# Product Change Notification

<b>Date Issued :</b>	October 27, 2023	<b>PCN Number :</b>	514085
<b>Reason for Change :</b>	Change Supplier		
<b>Description of Change :</b>	This notification is to inform you that Molex is planning to add dual source for metal backshells and impact the part(s) as per attached list. No changes will be made to product as part of this change.		
<b>Assessment of Change :</b>	First Article Inspection		
<b>Planned Implementation Date :</b>	April 27, 2024		
<b>Sample Availability Date:</b>	October 31, 2023		
<b>Internal Molex Qualification Date :</b>	October 31, 2023		
<b>Last date to request Samples by Customer :</b>	November 30, 2023		
<b>Traceability Code Markings / Date :</b>	Date code

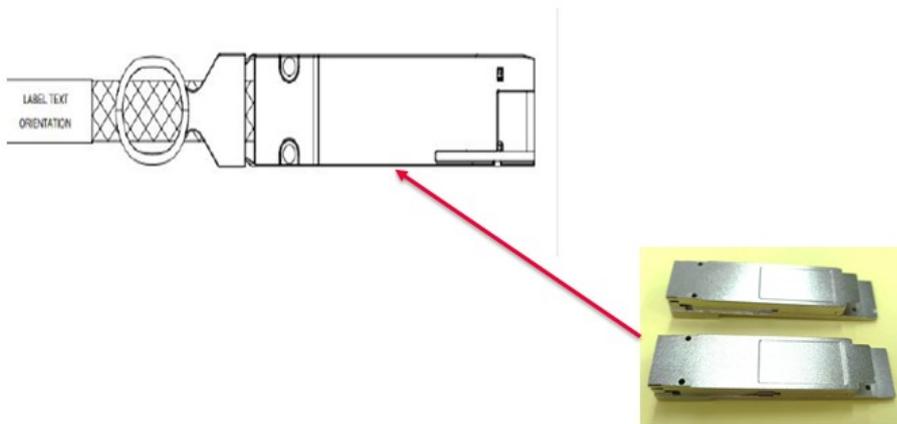
- Add dual source for metal backshells.
